PART VI | COMPARISON DRAWINGS

107 HIGH STREET, LINDFIELD, HAYWARDS HEATH, RH16 2HR

**PART VII | PROPOSED REGULARISATION
OF SCHEME**

PROPOSED REGULARISATION OF SCHEME
SUMMARY

COMPARISON - ROOF PLAN. 1:100@A3

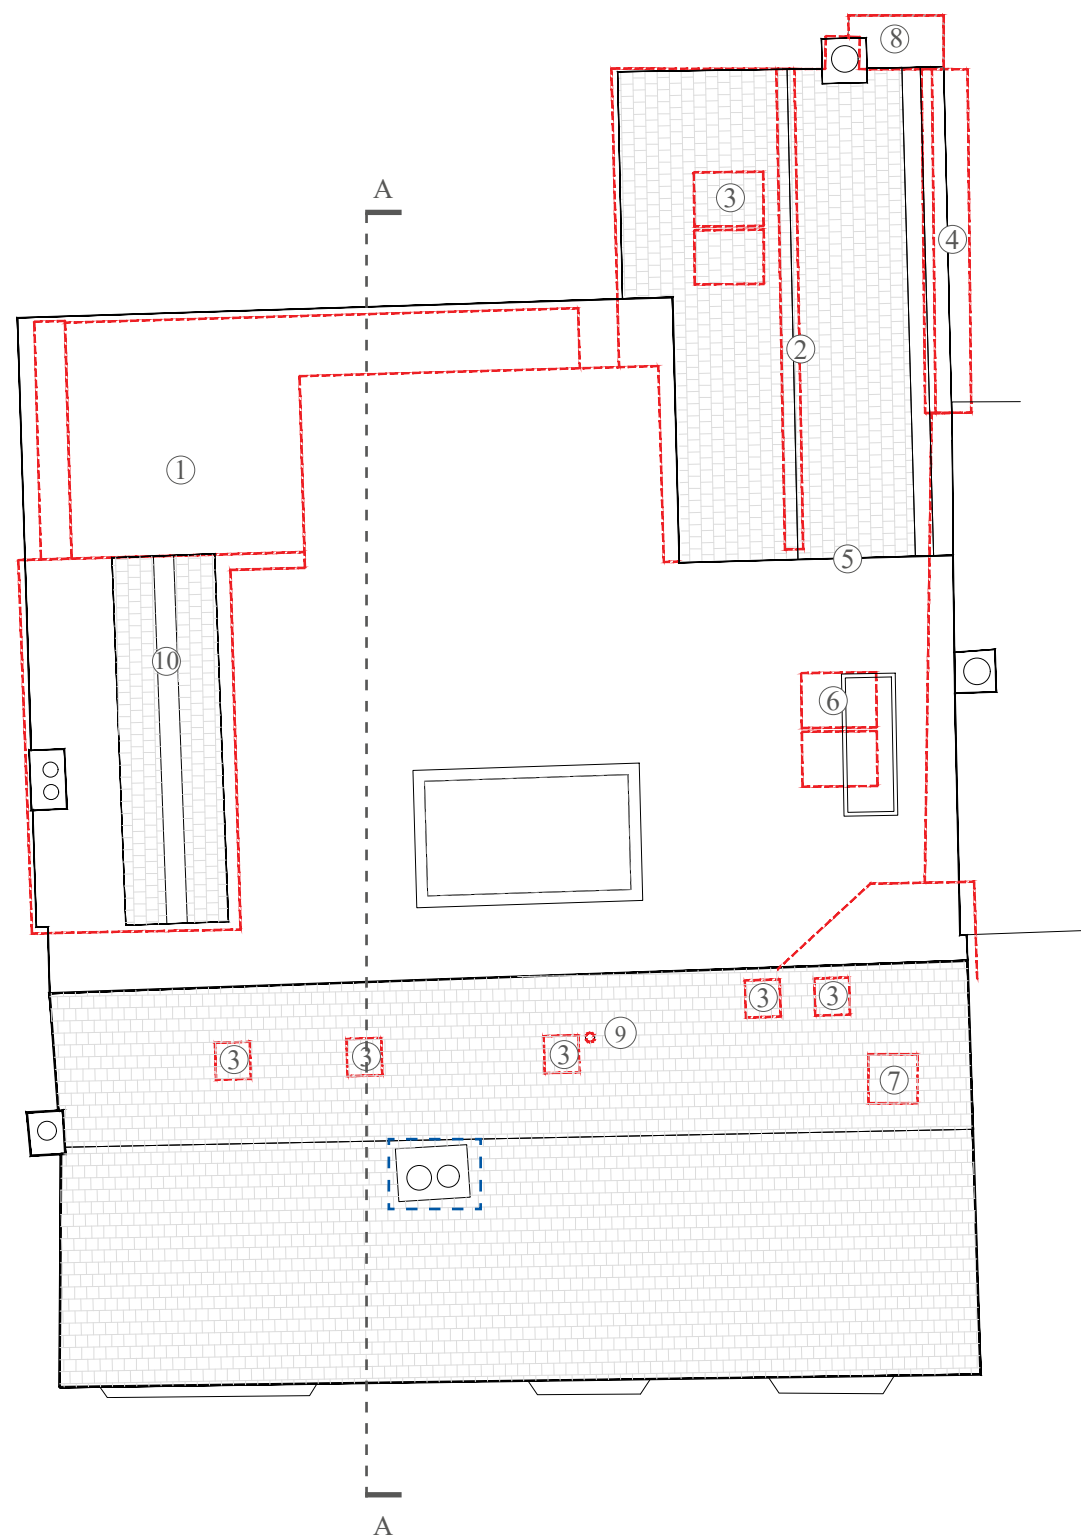
1. Rear extension extended - spanning full width, concealing the historic gable
2. Historic bake house re-constructed following its collapse during strip-out.
3. Rooflights omitted (7no)
4. Gutter design deviates from approved- parapet wall and secret gutter
5. No step between roof planes
6. Single rooflight instead of two
7. Existing chimney removed
8. AC AHU louvred timber enclosure - matching timber of new extension
9. Boiler flue installed
10. Historic gable partially visible above new flat roof

COMPARISON - WEST ELEVATION. 1:50@A3

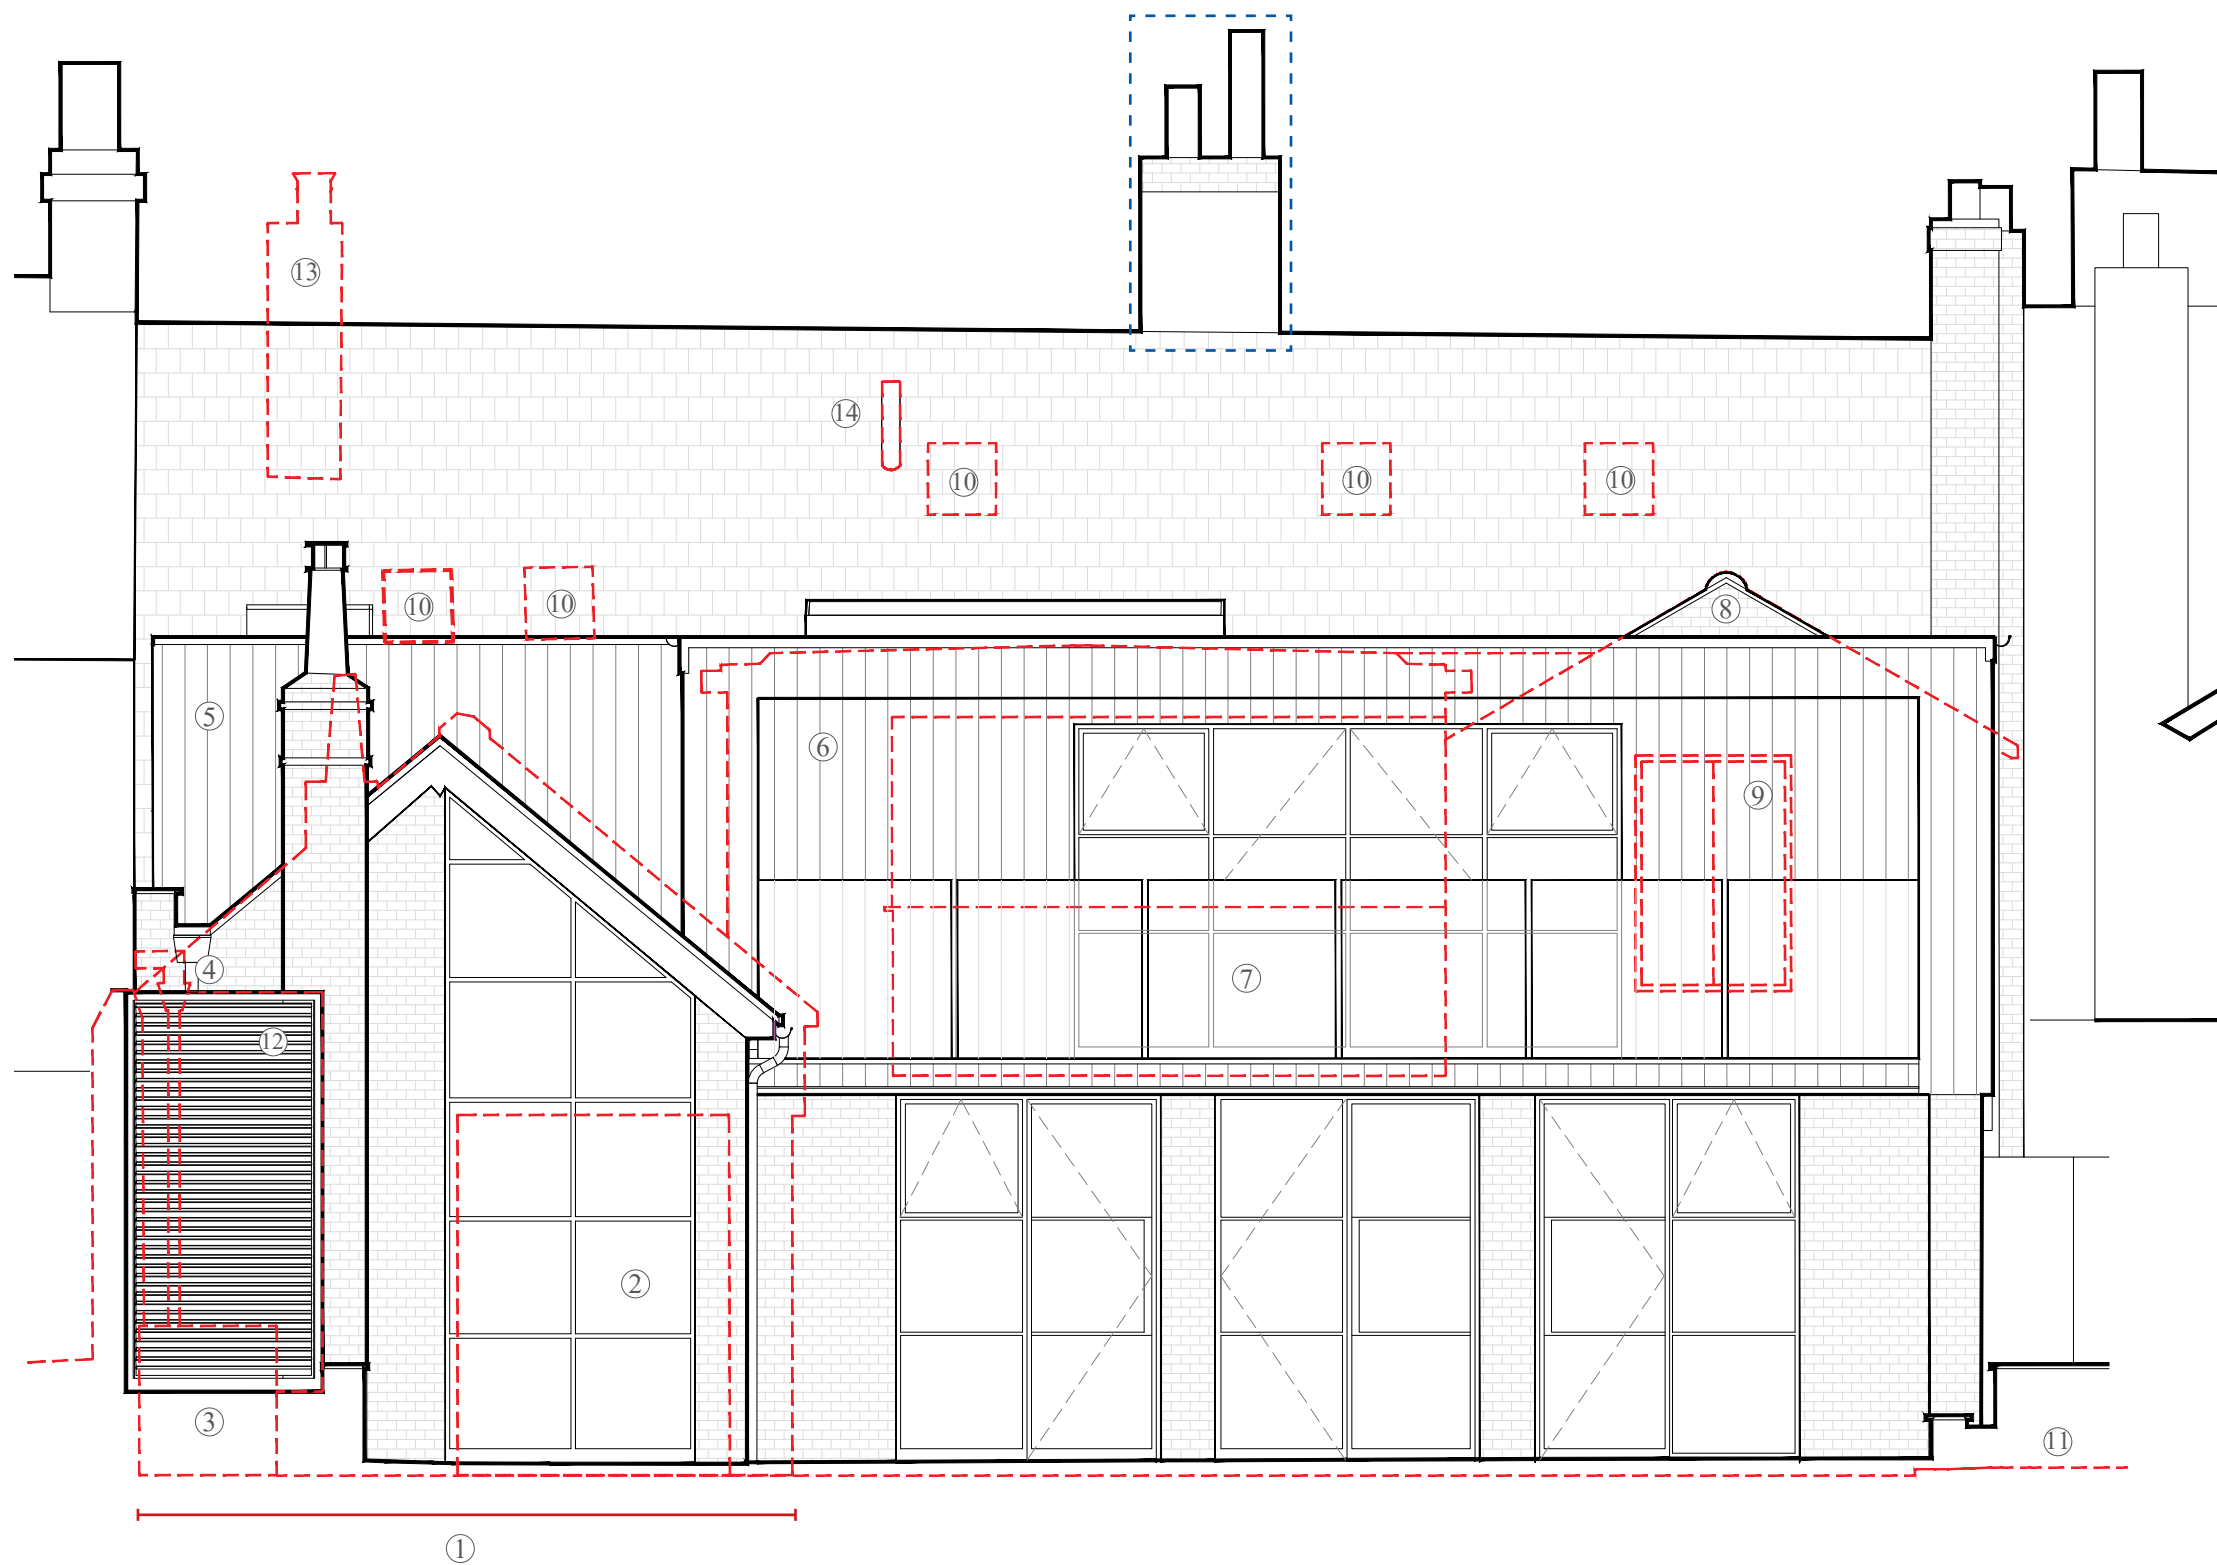
1. Historic bake house re-constructed following its collapse during strip-out
2. Window of different design
3. Raised planter not constructed
4. Gutter design deviates from approved- parapet wall and secret gutter
5. Additional mass, flat roof
6. Rear extension extended - spanning full width, concealing the historic gable
7. Terrace balustrade glazed instead of metal
8. Historic gabled extension retained but hidden behind new rear extension
9. Gothic window retained but hidden behind new rear extension wall
10. Rooflights omitted
11. Landscape design deviates from approved
12. AC AHU louvred timber enclosure - matching timber of new extension
13. Existing chimney removed
14. Boiler flue

COMPARISON - SOUTH ELEVATION. 1:50@A3

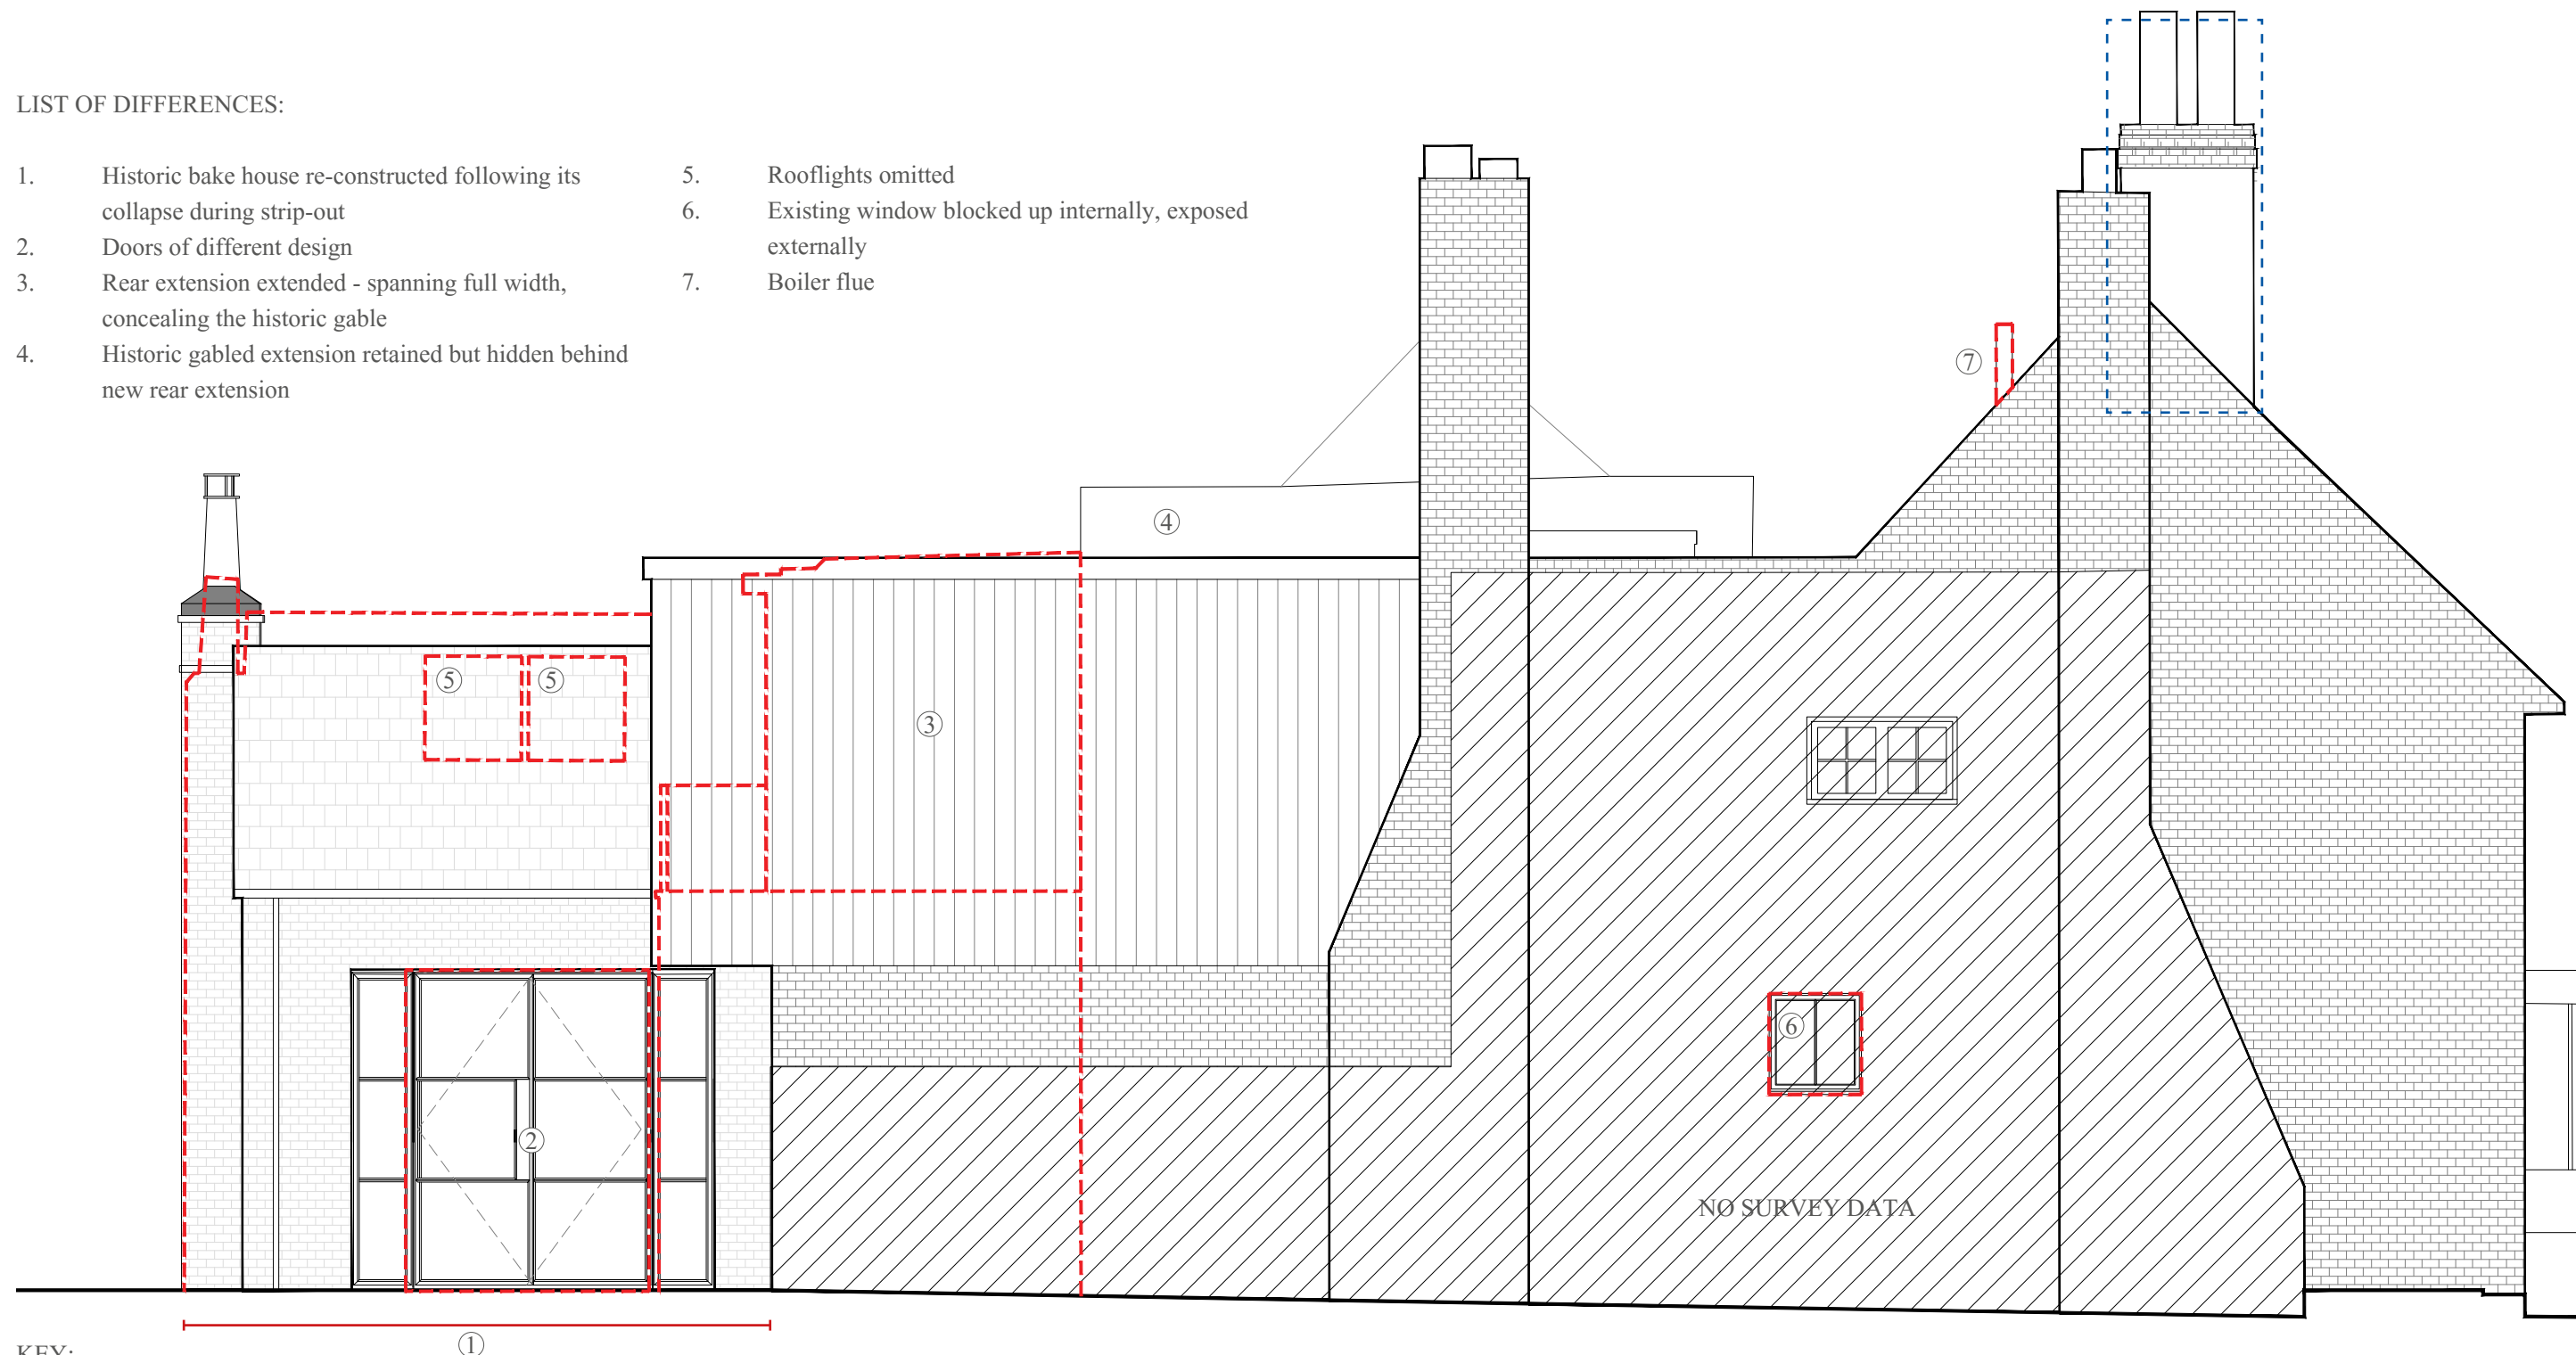
| 1. Historic bake house re-constructed following its collapse during strip-out | 5. Rooflights omitted |
| 2. Doors of different design | 6. Existing window blocked up internally, exposed externally |
| 3. Rear extension extended - spanning full width, concealing the historic gable | 7. Boiler flue |
| 4. Historic gabled extension retained but hidden behind new rear extension | |
